CLERK'S CONTRACT and AGREEMENT COVER PAGE

Contract Description: Design-Build John Humphrey Complex Renovation (+ \$160,838 contingency)
C19-0080 Addendum A Peat Mitigation & 4" path (2019-0375 \$547,666 + \$109,400 contingency)
C19-0141 Addendum B Additional Work (2019-0647 \$262,324)

ADDENDUM B to
John Humphrey Complex Renovations

Change Order Proposal #2

Option 2.1 - Concession Building
Concrete

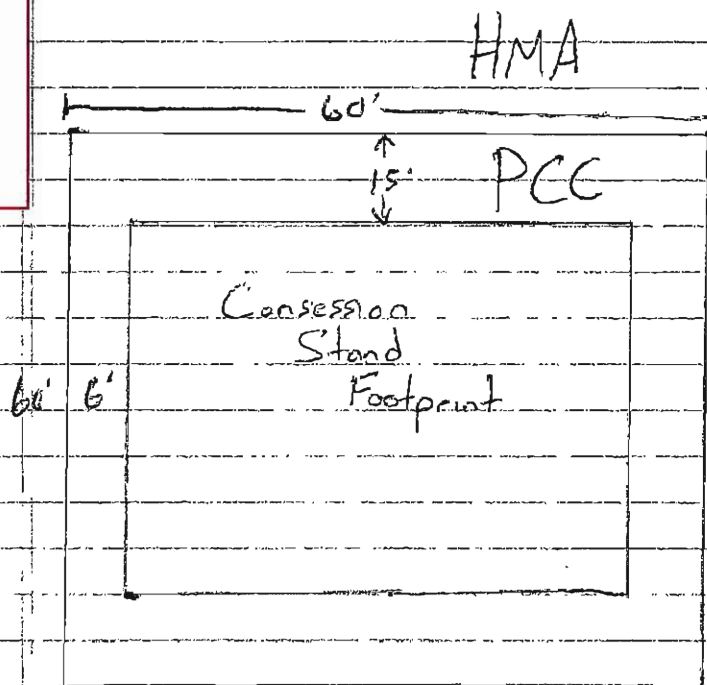
Concrete being removed and replaced
around the concession stand in it's
entirety

$$60 \times 15 = 900 \times 2 = 1800$$

$$30 \times 6 = 180 \times 2 = 360 = 2,160 \text{ SF}$$

1.0 This change order proposal is to remove & replace the PCC flatwork around the existing concession building. See attached sketch for limits of R&R.

Option 2.6 - Outfall Pipe Revision

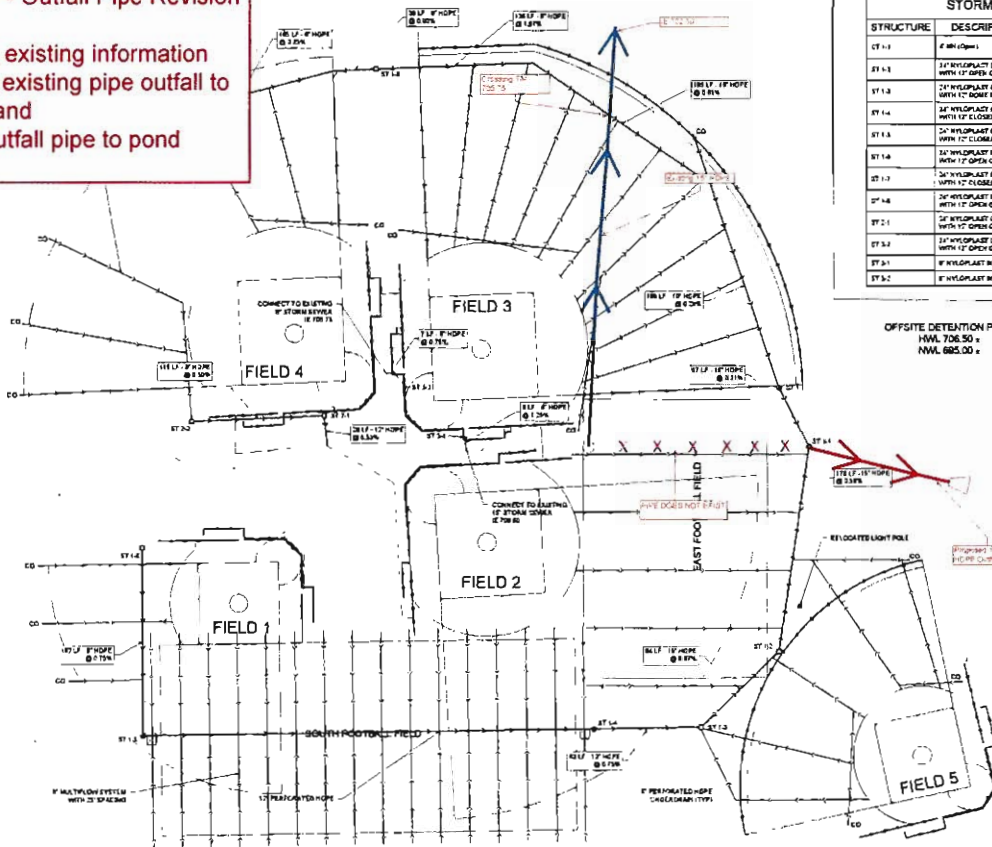
- * Incorrect existing information
- * Updated existing pipe outfall to north wetland
- * Added outfall pipe to pond

STORM OUTFALL REVISION		QUANTITY	UNIT	UNIT PRICE	TOTAL
1.10	OUTFALL PIPE INSTALLATION				
1.11	Sawcut Existing PCC Flatwork	120.000	lf	\$ 55.00	\$ 6,600.00
1.12	FES; 18" RCP	1.000	LS	\$ 1,700.00	\$ 1,700.00
1.13	Structure Adjustment	1.000	EA	\$ 900.00	\$ 900.00
PROPOSAL TOTAL:					\$ 9,200.00

UTILITY PLAN
 JOHN HUMPHREY SPORTS COMPLEX
 C5.0

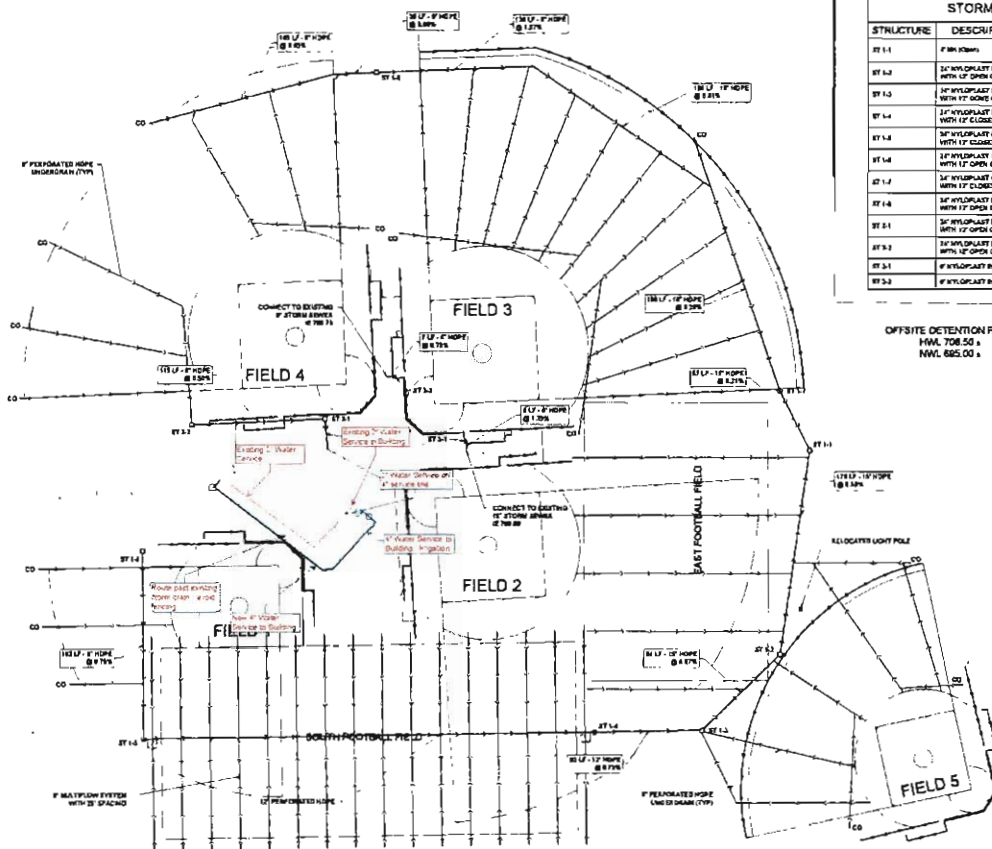
- 1) All poles will be painted in place
- 2) Poles will be cleaned by power washing (min 2,000 psi)
- 3) Poles will be scraped to remove loose material (wire brush and/or hand-held tool)
- 4) Poles with areas of rust will be wire brushed or sanded
- 5) Bare surfaces will be primed with metal primer
- 6) Finish coat of a high-performance acrylic, high gloss black paint will be applied
- 7) Thorne Electric will provide a one-year warranty to include manufacturers defects and any cracking or spalling of paint.
- 8) Warranty begins upon completion of the pole painting and Village acceptance of work.
- 9) Schedule if for pole painting to be complete by November 1, 2019.
